August 8, 2016
Serial: HNP-16-056

Shearon Harris Nuclear Power Plant, Unit 1
Docket No. 50-400
Renewed License No. NPF-63

Subject: Response to Second Request for Additional Information Regarding License
Amendment Request for Temporary Changes to Technical Specifications for the
'A' Emergency Service Water Pump Replacement

DUKE ENERGY
 NUCLEAR ENGINEERING DEPARTMENT - RALEIGH, N.C.
 HARRIS NUCLEAR PROJECT - UNIT 1
 NAME: NONE
 TITLE: SIMPLIFIED FLOW DIAGRAM
 SHEET 1 - UNIT 1
 NO. 0547

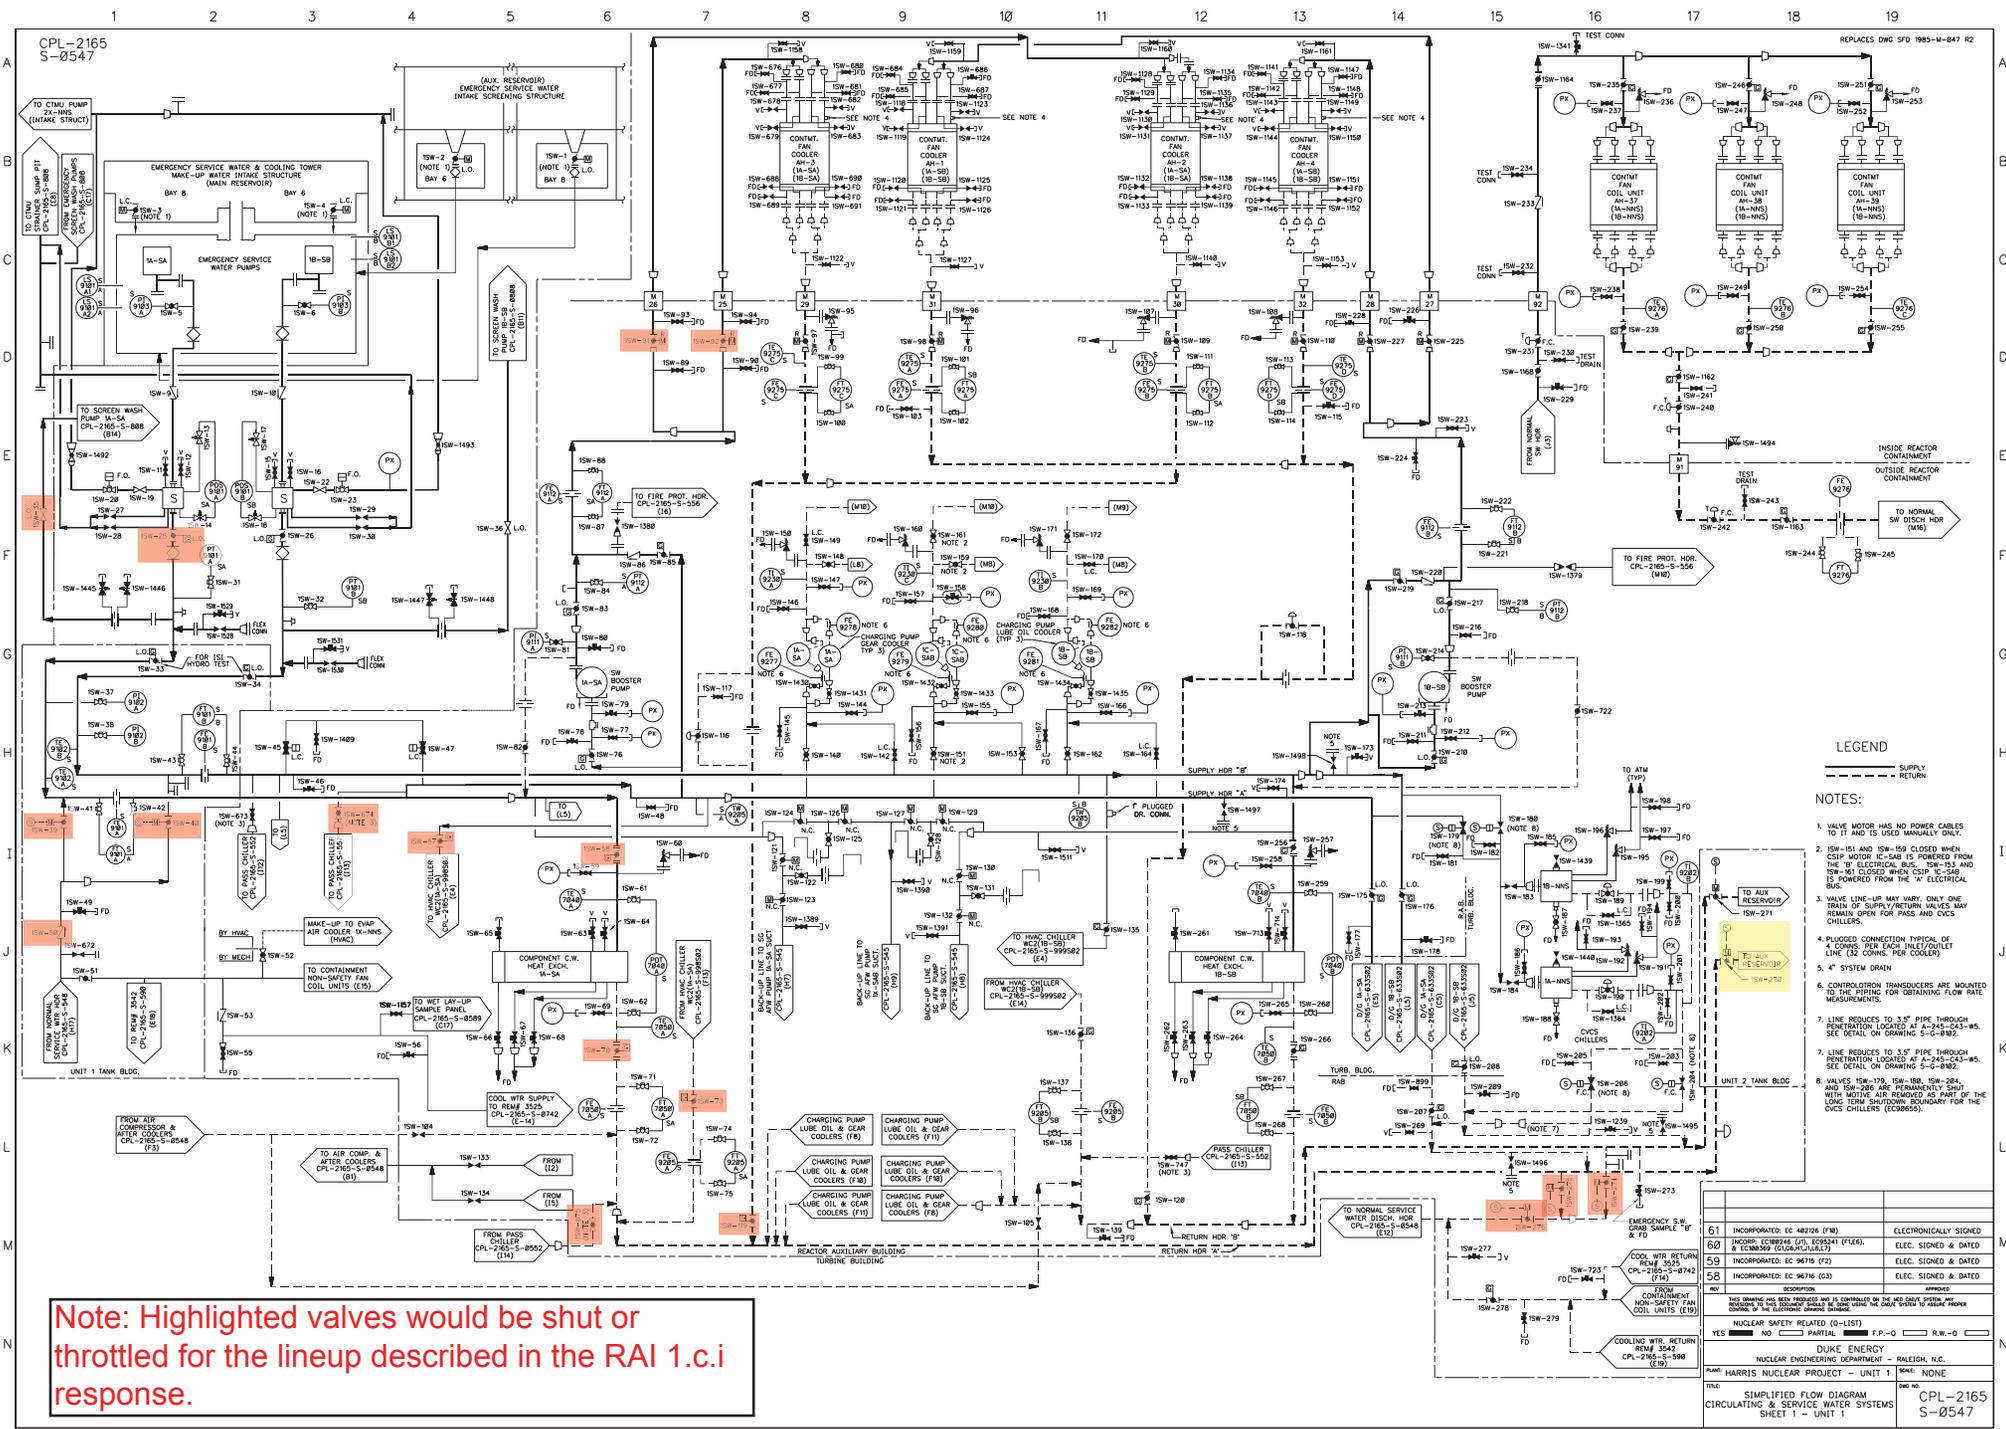
- i. Describe the ESW flow path to the operating EDG and other essential loads using the FLEX pump. Include a description of valve repositioning(s) necessary to support the cooling water lineup, including the valve manipulation(s) necessary to ensure water inventory only goes to the intended loads, and the estimated time needed to accomplish the lineup.

- ii. Provide the results of analyses or testing performed to demonstrate that FLEX cooling inventory loss expected due to leakage past the repositioned valves and back leakage via the ESW/Nuclear Service Water pump discharge check valves would not impair the ability of the FLEX pump to perform its intended compensatory defense-in-depth safety function of providing sufficient cooling flow to the loads assumed in this LAR.

- c.i. The valve lineup to accomplish this has been reviewed and personnel will be trained and available to execute the necessary isolations of other 'A' ESW loads, shown below, within a one-hour time frame. Attachment 5 of this submittal contains a simplified flow diagram of the circulating and service water systems that shows these valves for additional reference. Additional operator staff will be utilized. Operators will be trained and staged to support the necessary valve isolations. The 'A' EDG would be manually started to support the 'A' CSIP and 'A' AFW pump. The 'A' motor driven AFW pump and TDAFW pump will remove decay heat through the steam generators to transition the unit to hot shutdown.

scenario postulated for the 'A' ESW pump replacement. However, pump flow is limited largely by the NPSH available. In the response to RAI-1.a, it was shown that there would be about 135 gpm of margin available beyond that required to support operation of the 'A' EDG, the 'A' CSIP, the 'A' CCW HX, and an air compressor aftercooler. This margin can account for system boundary leakage.

The largest boundary valves are the 'A' ESW pump discharge isolation valve, 1SW-25, and the NSW supply and return isolation valves, 1SW-39 and 1SW-275. 1SW-25 is a 30" manually operated (gear-operated) stainless-steel butterfly valve with a Tefzel seat that was replaced in refueling outage (RFO) -17 (the original carbon steel valve was replaced with a new stainless-steel valve). Given the construction of this valve, its recent installation, and the presence of the upstream check valve (1SW-9), it is reasonable to expect very little leakage back into the ESW Intake Structure.

The NSW supply and return isolation valves, 1SW-39 and 1SW-275, are 30" motor-operated stainless-steel butterfly valves with Tefzel seats. 1SW-39 was inspected, cleaned, and diagnostic testing performed (no leak testing) during RFO-19 in 2015. Check valve 1SW-50 is located upstream of 1SW-39 and provides some additional isolation from the NSW system. 1SW-275 had diagnostic testing (no leak testing) performed in RFO-19 and on-line during Cycle 20. There is also another butterfly valve, 1SW-276, of similar construction located downstream of 1SW-275 to provide additional isolation capability. Based on these details, no significant amount of leakage is expected past these boundaries.

Numerous SW system valves have been recently replaced, which provide additional confidence that the 'B' ESW system will start and run if necessary. The NSW supply valves to the 'A' and 'B' ESW headers, 1SW-39 was replaced in RFO-19 and 1SW-40 was replaced in RFO-16 and both valves have shown good performance (shown on the SW diagram included in Attachment 5). NSW flow discharge valves 1SW-274, replaced in RFO-18, and 1SW-276, replaced in RFO-19, have shown good performance (shown on the SW diagram included in Attachment 5).

Note: Highlighted valves would be shut or throttled for the lineup described in the RAI 1.c.i response.
